BOLT, MACHINE - DOUBLE HEXAGON EXTENDED WASHER HEAD, DRILLED, PD SHANK, NICKEL ALLOY, UNS N07718, 185 KSI MIN, .3125-24 UNJF-3A

AS3245™
SHEET 1 OF 3

REV. D

FIGURE 1 - BOLT

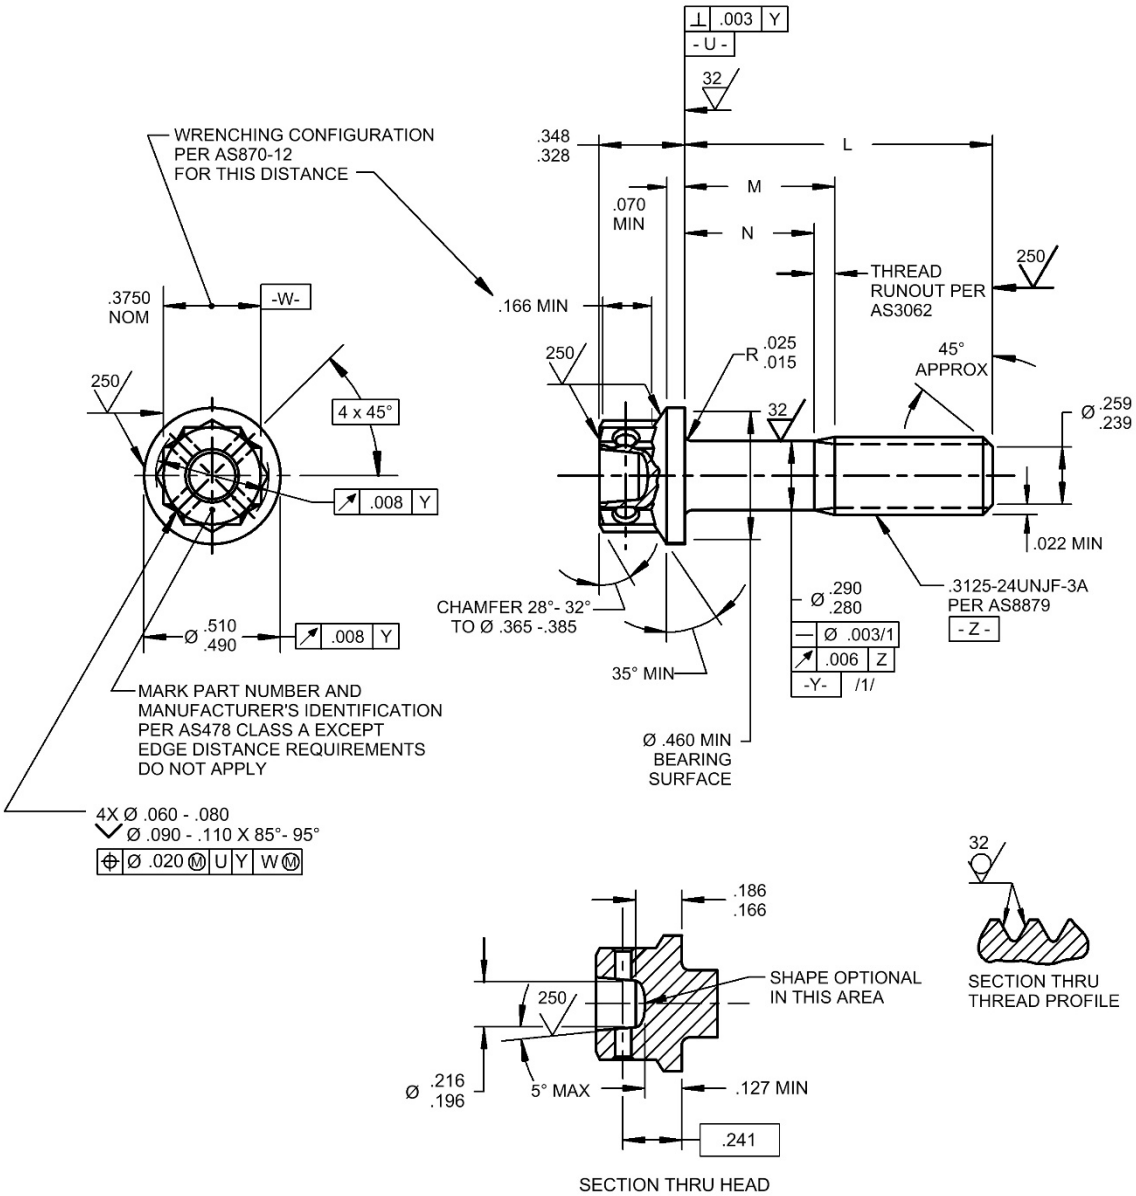
REVISE LEAD THREAD CHAMFER TO CONFORM TO AS1132J, UPDATE FPI REFERENCE, ADD NEW NOTE 9 FOR USE OF EXISTING INVENTORY, EDITORIAL UPDATES TO FIGURE 1.
